STAFF REPORT: 04/09/2025 MEETING
ADDRESS: 3964 W. LAFAYETTE
APPLICATION NO: HDC2025-00087
HISTORIC DISTRICT: HUBBARD FARMS
APPLICANT: JAMIE PEREZ

SCOPE: ERECT CARRIAGE HOUSE

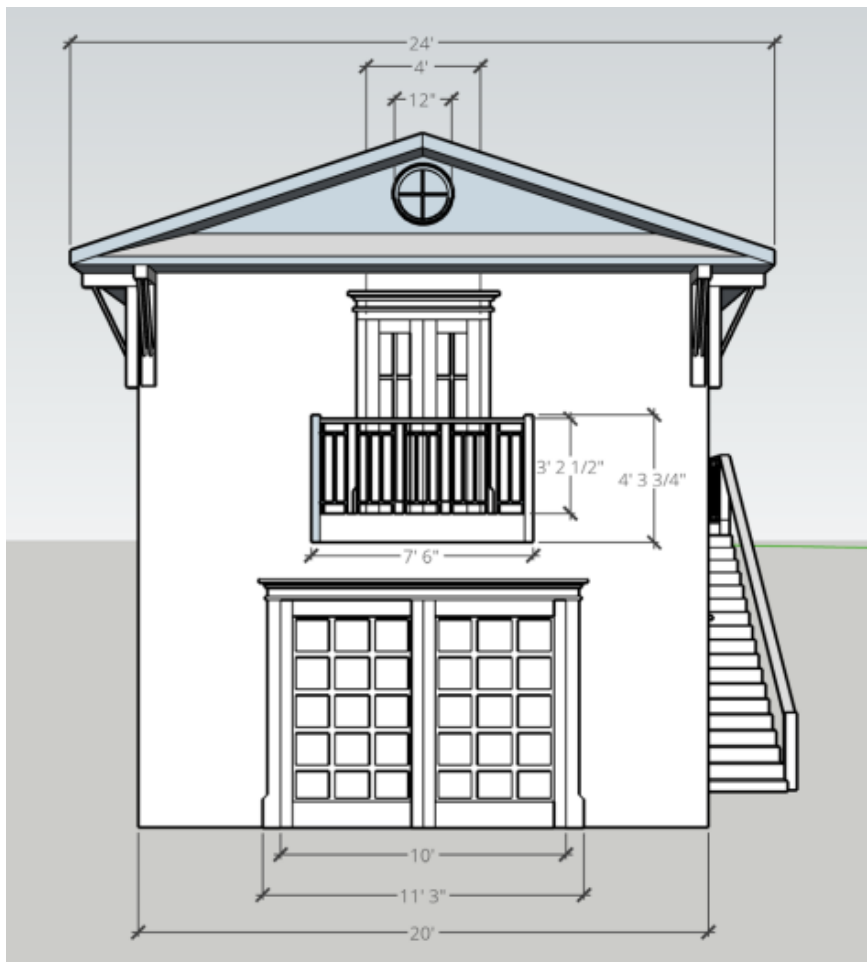
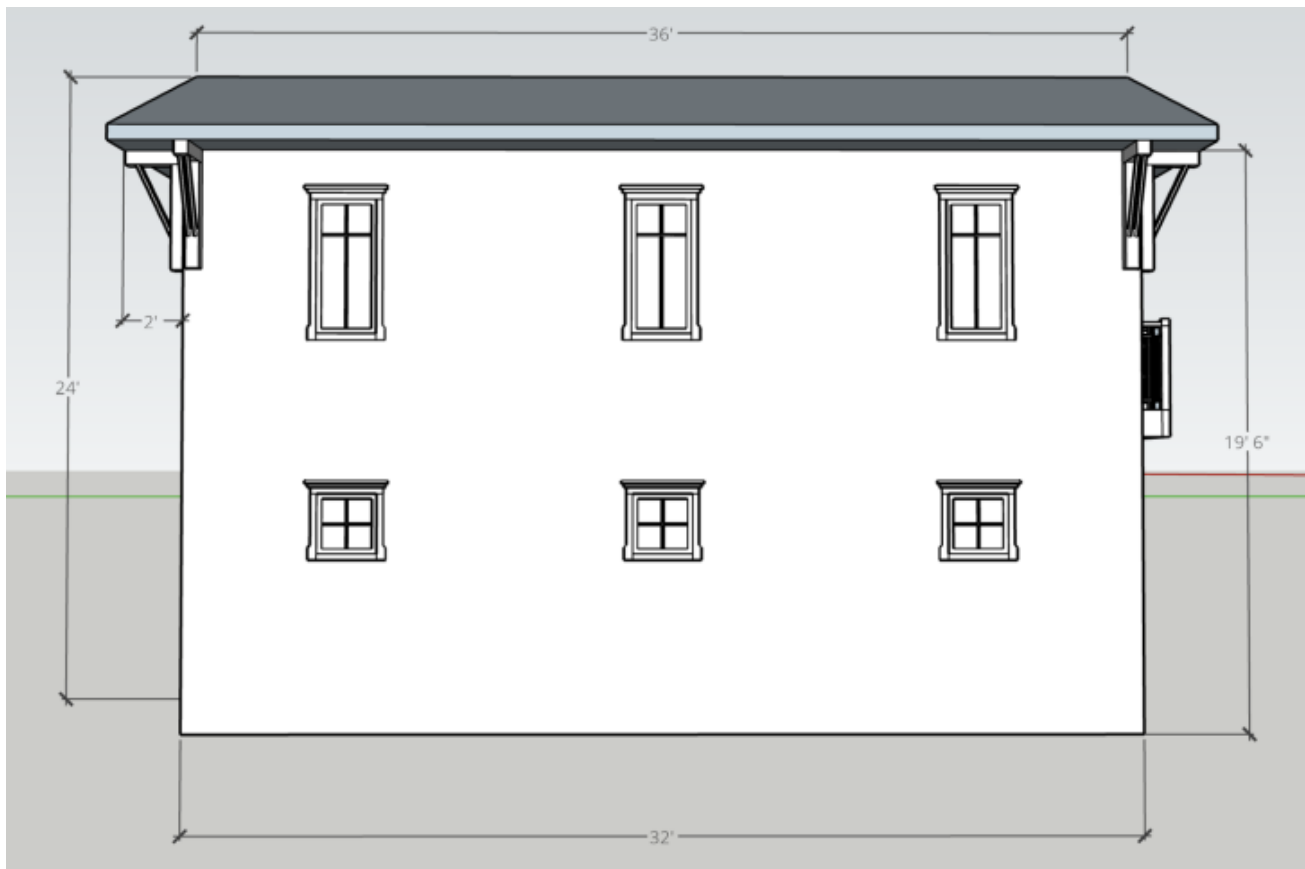
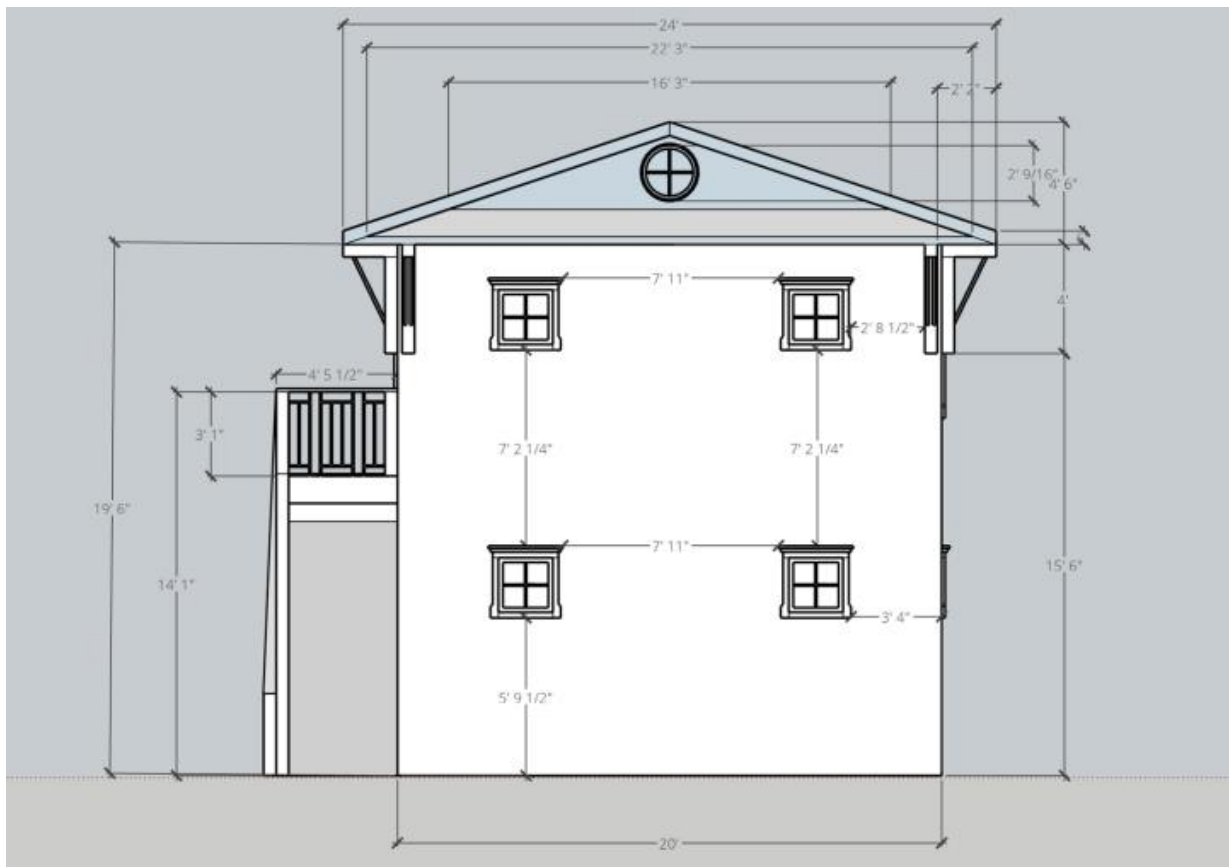
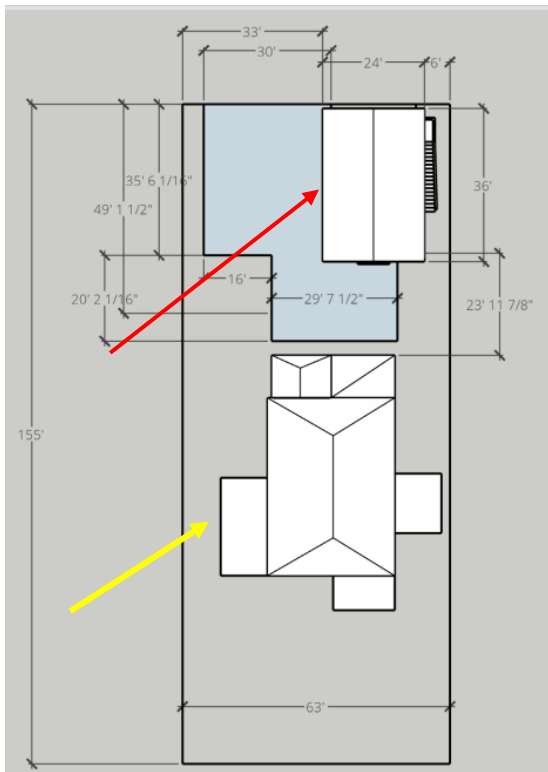
Staff Assessment – Recommend revisions to the project design. The applicant has noted that the carriage house will incorporate “...several key design elements” in an effort to ensure its compatibility with the Spanish Colonial Revival style historic house at 3964 W. Lafayette, such as the “...bracket details, exterior door and window trim, muntin patterns, the scale of the wooden casement windows, the selection of a hinged garage door, overhang depth, and the overall proportions of the building.” Also note that the exterior walls will be clad with lapped cement fiber siding (with a finish color to match the house) and the roof will be gabled with ocular windows within each end.

While staff does appreciate the project’s attention to detail, staff does recommend that the design be revised slightly to ensure that the new construction is distinctive from, compatible with, and subordinate to the property’s historic house as required by the Standards and Guidelines, especially since it will be highly visible from Hubbard Street. Specifically, since the applicant is seeking to incorporate design elements which do have a strong association with the Spanish Colonial Revival, such as the decorative wood trim details and the coffered wood garage doors, staff recommends that **all other elements be muted/simple stated** so that the building does not create a false sense of history and that it does not compete with/is subordinate to the house’s design. The proposed use of lapped wood cement fiber siding conforms to this requirement as it is different from the historic house’s cladding, but will be finished with a color which matches the stucco. Also, per the district’s Elements of Design (7) *Relationship of materials* “...many wood frame buildings are clad in clapboard.” However, the incorporation of triangular brackets, a detail which is typically associated with the Arts and Crafts style, is not compatible with the property’s historic house style, in staff’s opinion. Also, the gabled roof form with ocular windows at the gable ends is not compatible with the house’s design and the Spanish Colonial Revival elements which the applicant proposes to incorporate in the carriage house’s design. Rather, staff recommends that the carriage house have a simple hipped roof (consistent with the historic house’s roof) and that the proposed overhanging eaves be open/lack brackets, to indicate that it is distinctively new construction.

- Finally, note the new building will house two stories and will measure 24’-0” in height to the ridge line. The applicant noted that the height of the carriage house will be lower than that of the historic house as it is “approximately 33’-0”-high. Note that staff is unsure if the stated 33’ dimension is referring to the height of the house at its ridge line or eaves. Staff therefore recommends that the applicant submit a section drawing of the historic house which indicates the exact heights at the eaves and ridge line to staff for review and approval prior to the permit’s issuance so that staff can confirm that the height differential between the historic house and new carriage house is appropriate.

- The carriage house shall have a simple hipped roof (to match the house), with open, overhanging eaves which lack brackets, to indicate that it is distinctively new construction. The revised design shall be submitted shall be submitted to staff for review and approval prior to the permit's issuance
- The applicant shall submit a section drawing of the historic house which indicates its exact heights at the eaves and ridge line to staff for review and approval prior to the permit's issuance
- The applicant shall provide cutsheets which specifically depict the appearance of the new hardscape that is proposed for installation within the rear yard to HDC staff for review and approval prior to the issuance of the project's permit.

Site plan, showing new carriage house (indicated by red arrow) and hardscape. The historic house (indicated by yellow arrow) is to the south of the new building.

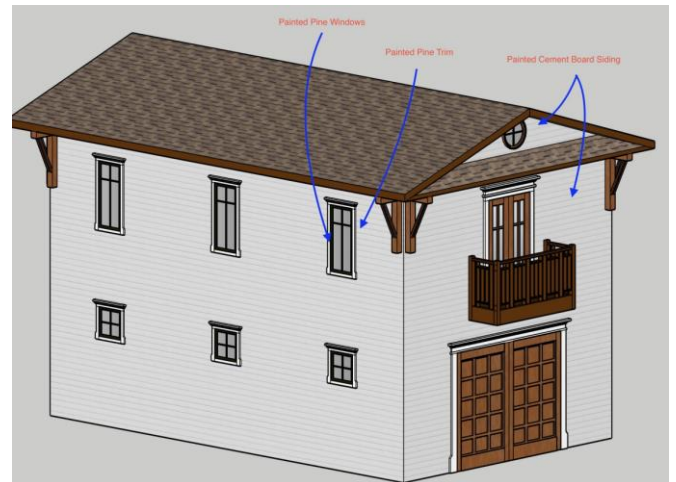
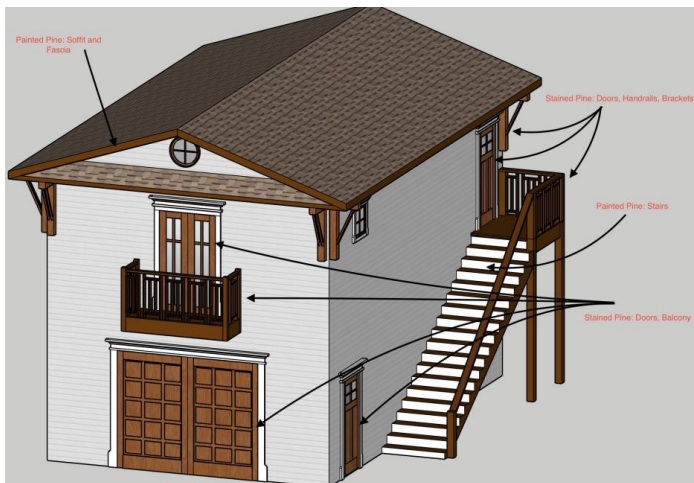
- Note that the application does not include cutsheets which specifically depict the appearance of the new hardscape that is proposed for installation within the rear yard. Staff therefore recommends that the applicant provide that information for review and approval prior to the issuance of the project's permit.
